# Castle Rock Watershed Comment Form

Please provide the following information:		DATE: August 10, 2022
COUNTY NAME: Portage	COMMUNITY NAME:	
NAME: Dan Bowers	TITLE: Assistant Director, Planning and Zoning	
ADDRESS: 1462 Strongs Avenue, Stevens Point, WI 54481		
DAYTIME PHONE: 715 346 1334	E-MAIL: <a href="mailto:bowersd@co.portage.wi.us">bowersd@co.portage.wi.us</a>

Item 1. Clusters of LOMC  
 Center: 89°34'40"W 44°28'39"N

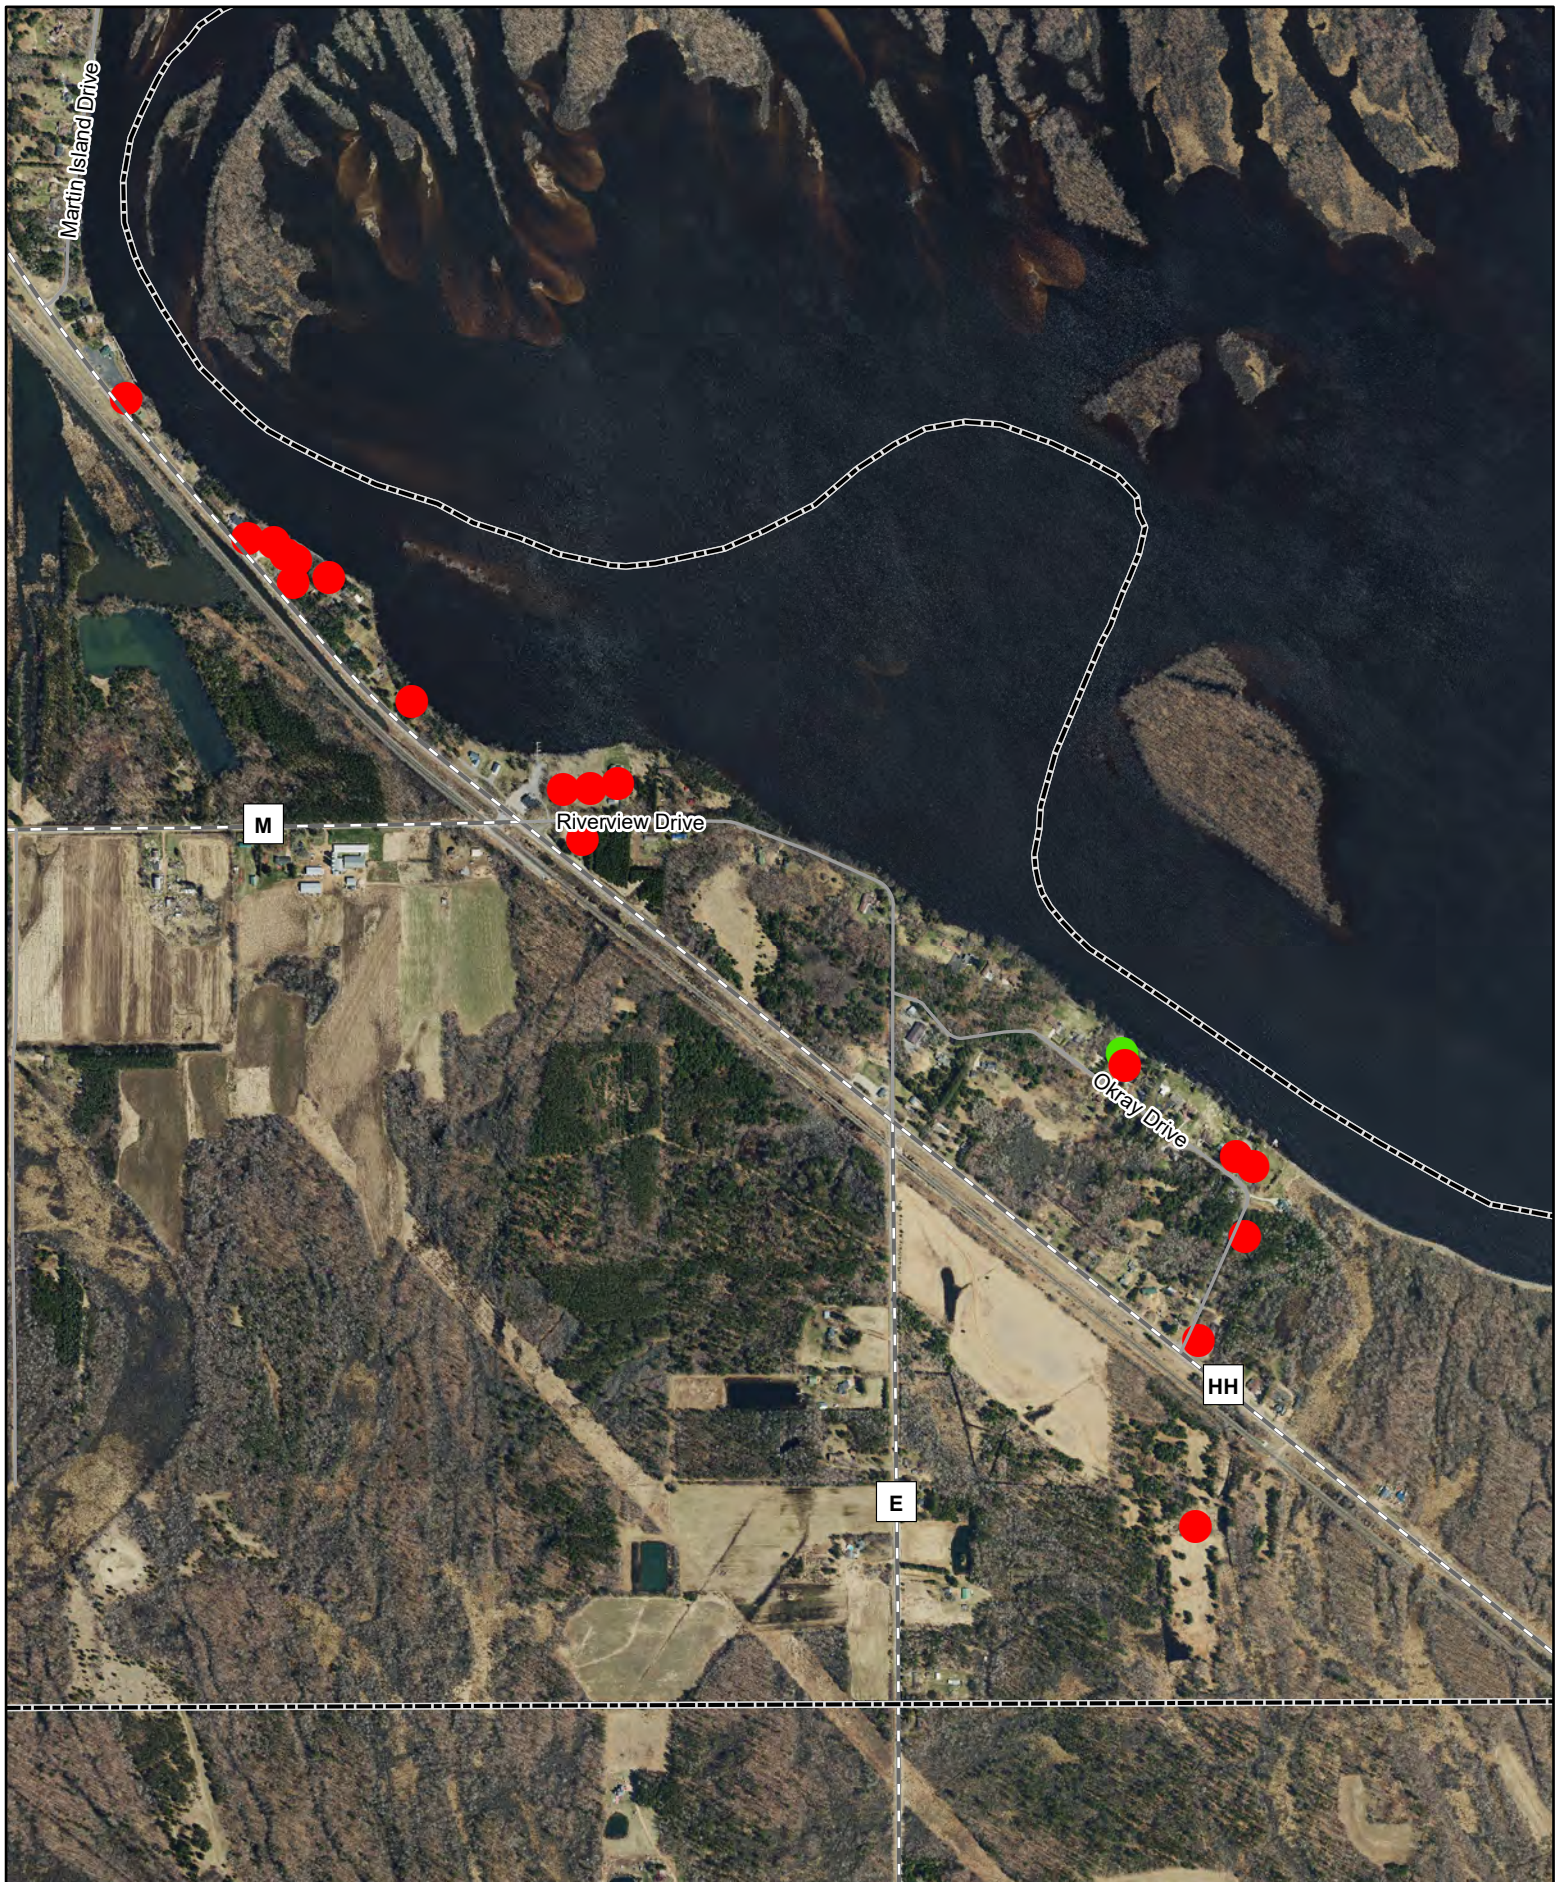
Item 1. Clusters of LOMC on the Wisconsin River. Maps Attached.

Mill Creek : HUC 0707000302

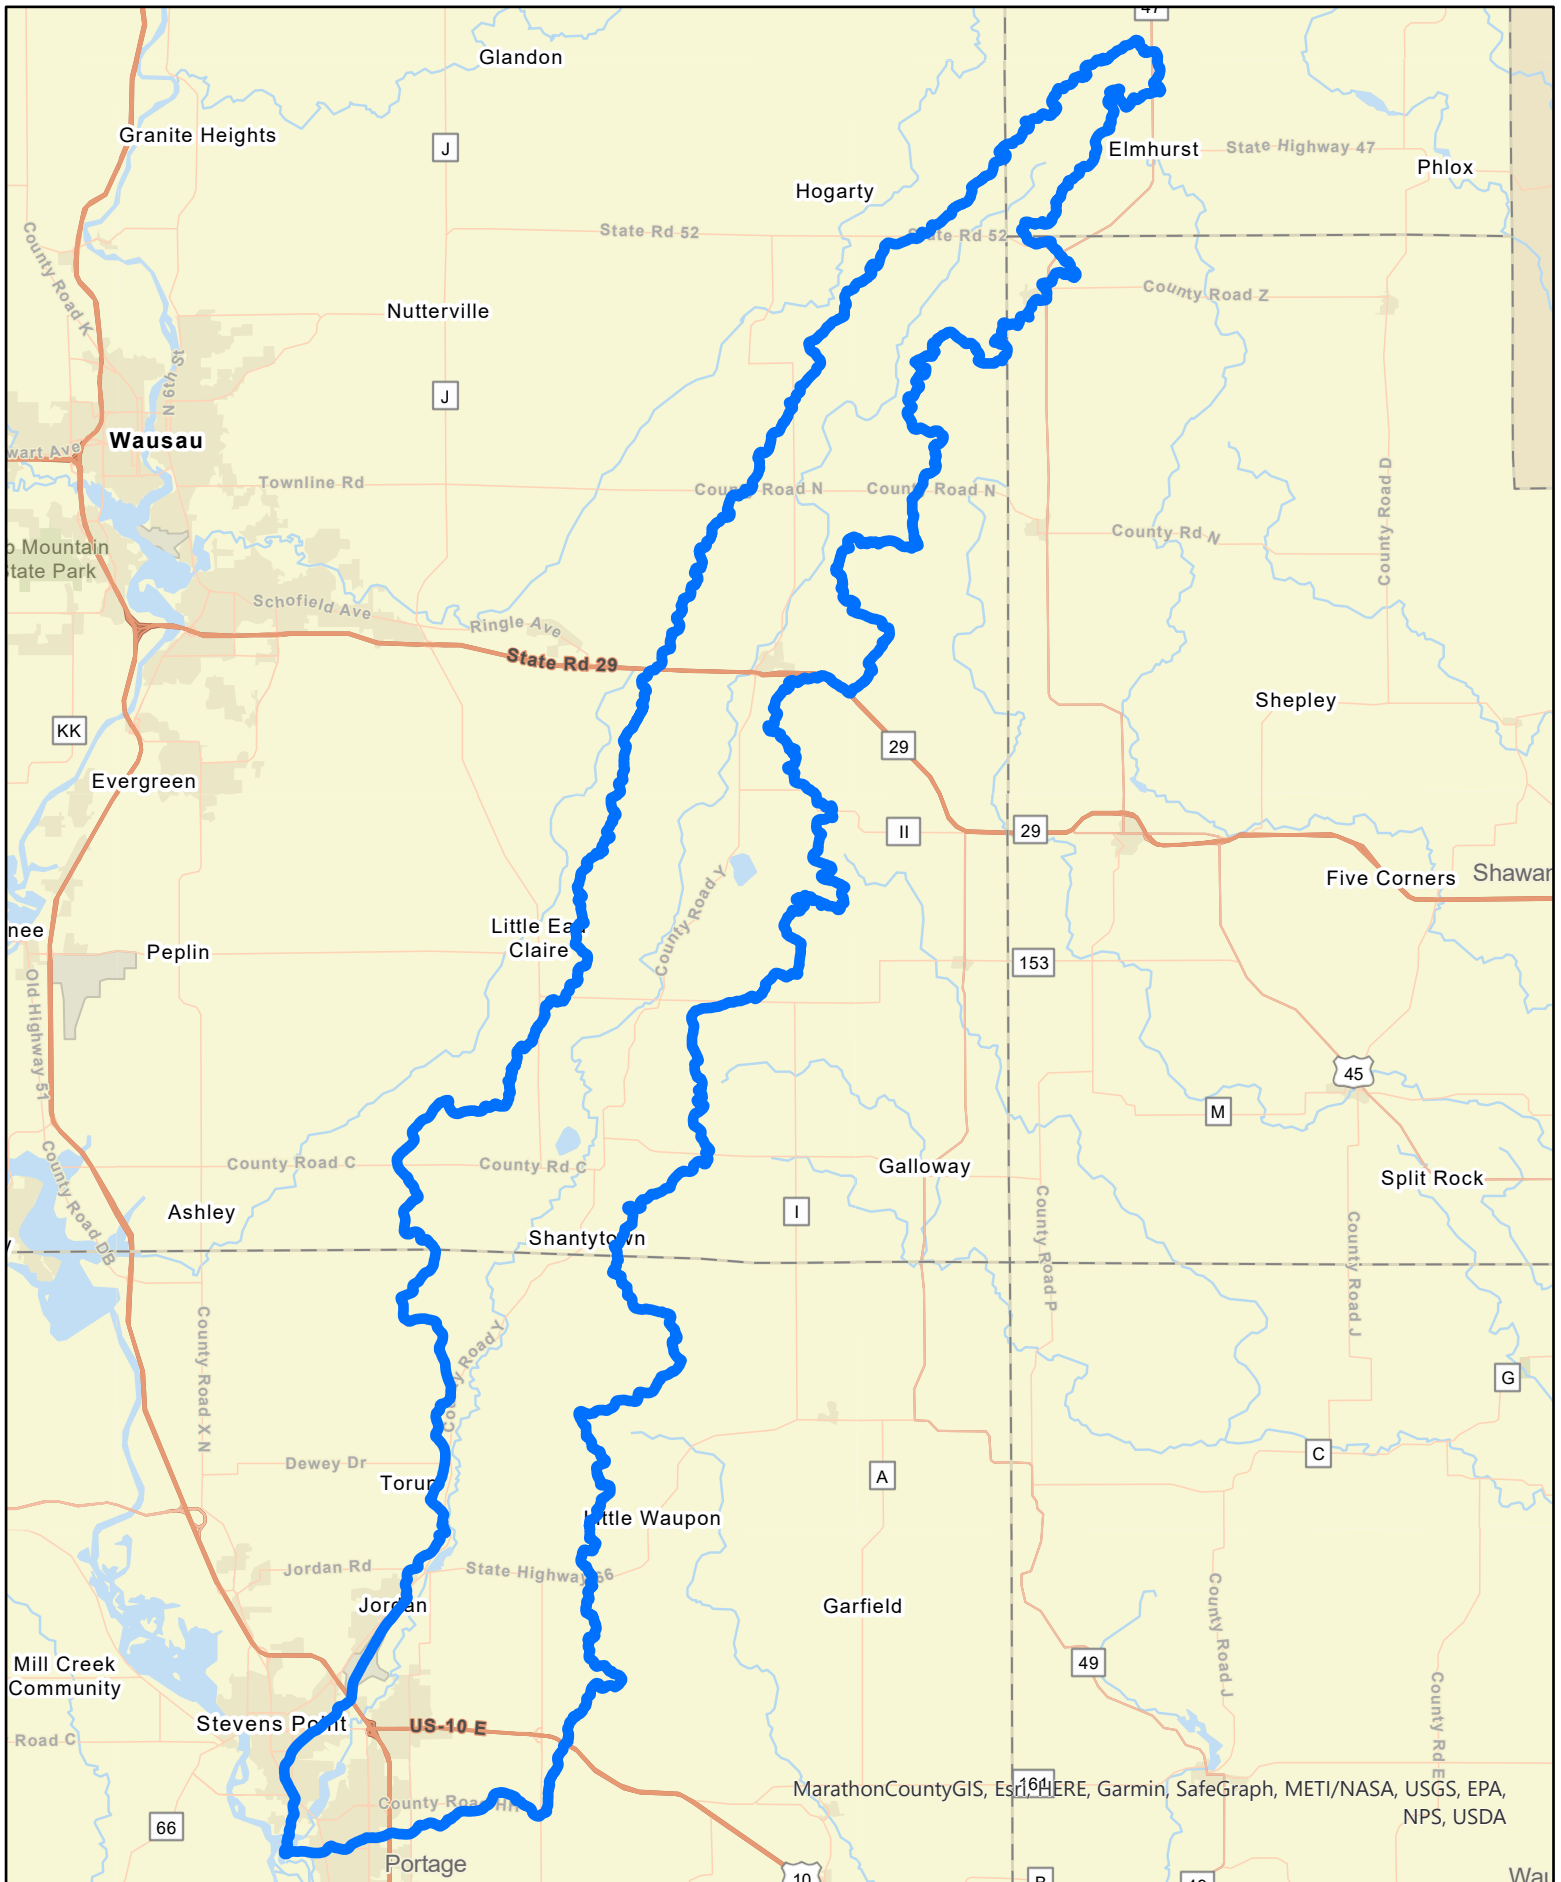
Item 4. There are four streams where there is or will be development, that are unstudied: Mill Creek, Plover River, Lake DuBay, and Little Eau Pleine River. We understand that Lake Dubay and Little Eau Pleine River are on the edge of the scope for this project but Portage County would be willing to cost share with technical assistance from DNR and/or FEMA for the study and mapping of these bodies of water. Maps Attached.

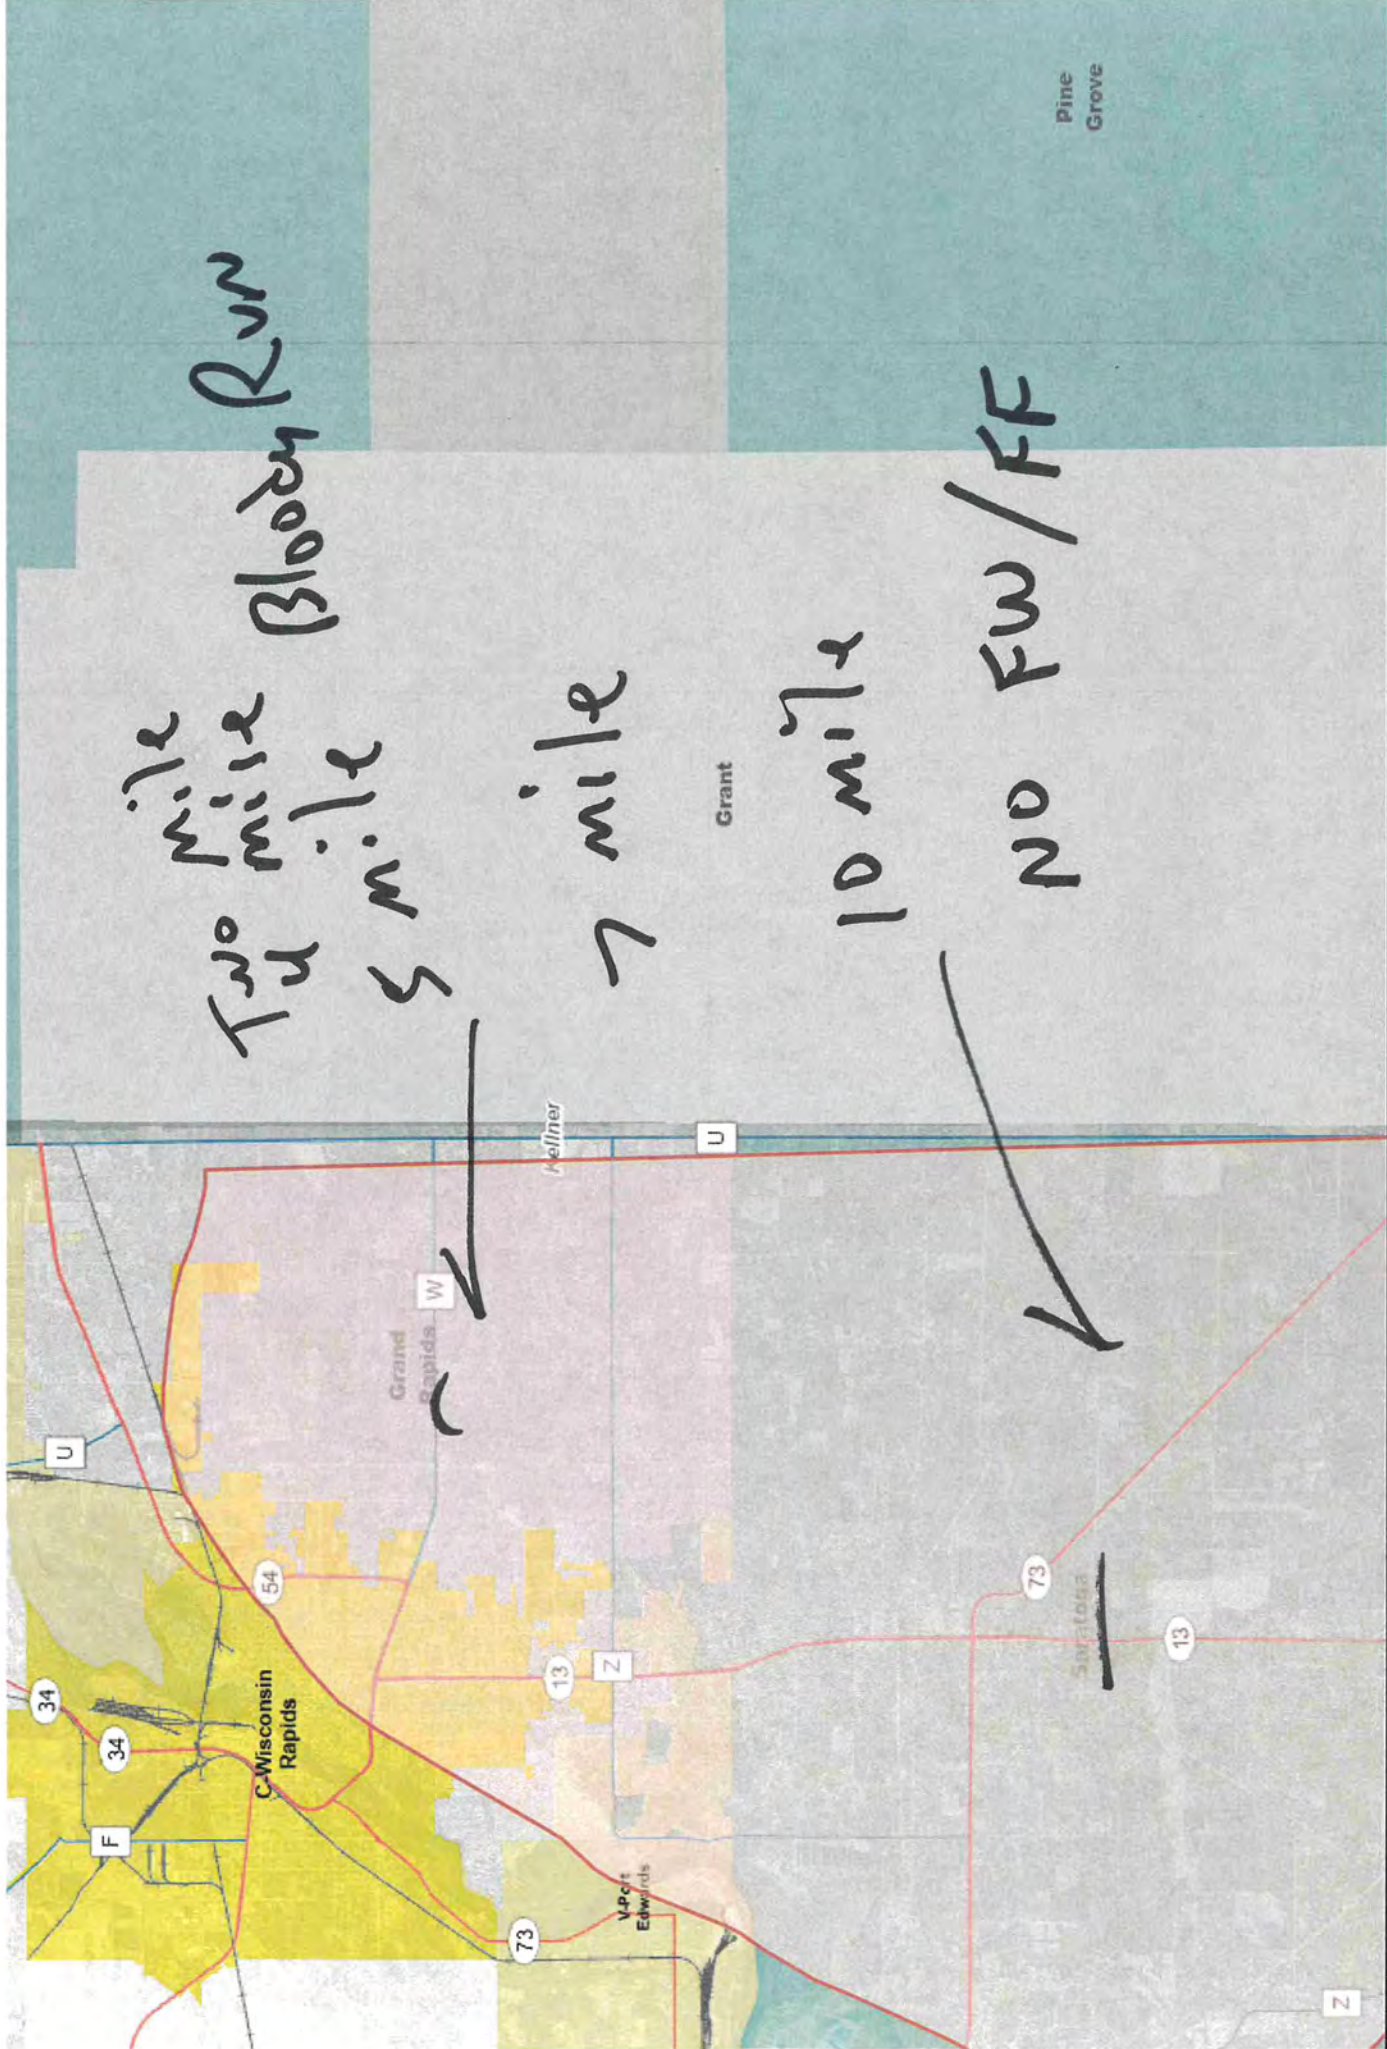
#5 The Town of Grand Rapids has approximately 7,400 people with strong development continuing today. All of the small streams have BFE data that is questionable and there is no floodway/flood fringe identified. This is regulated, as all floodway causing a large number of unstudied LOMA's to pop up. So, we are getting development without any studies.

I am asking for floodway/flood fringe to be identified for two Mile Creek, Five Mile Creek, Seven Mile Creek and Ten Mile Creek.

Also Four Mile Creek - Large amount of development - Home improvement etc...

Bloody Run Creek as well.

Saratoya also has large population.
